Berlin Farm West

FINAL DEVELOPMENT PLAN PHASE 7, 9 & 11

Berlin Township – Piatt and Berlin Station Roads
Delaware County, Ohio

June 17, 2025

FIGURE 2

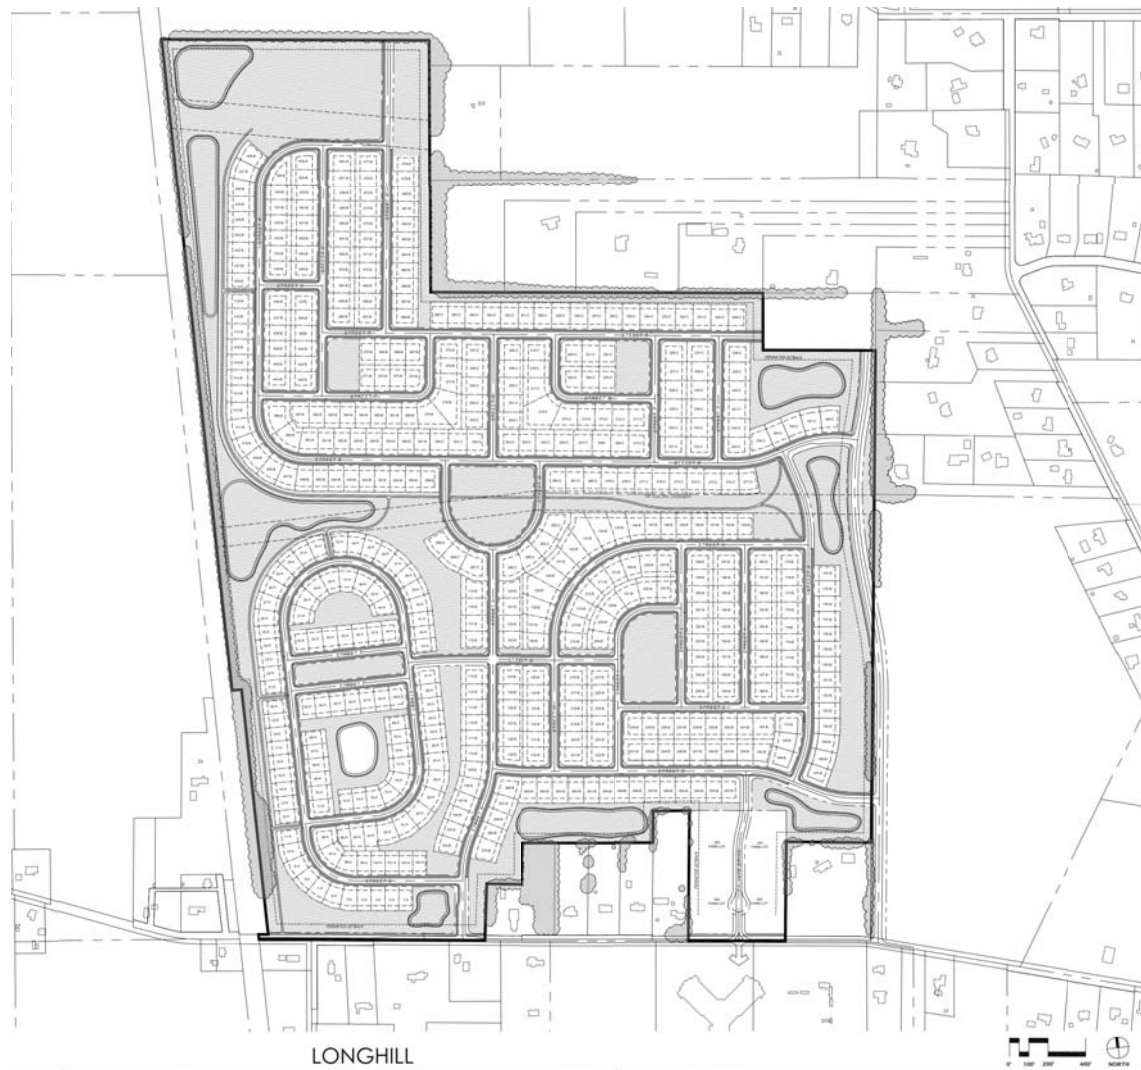
Assume single lane roundabout at Berlin Station/Piatt as the E+C condition. Show as "by others" in all exhibits

Is this the current site plan? A
RI-RO will not be permitted
opposite the school entrance

Show roundabout at the
intersection of Berlin Station &
Piatt Road "by others"
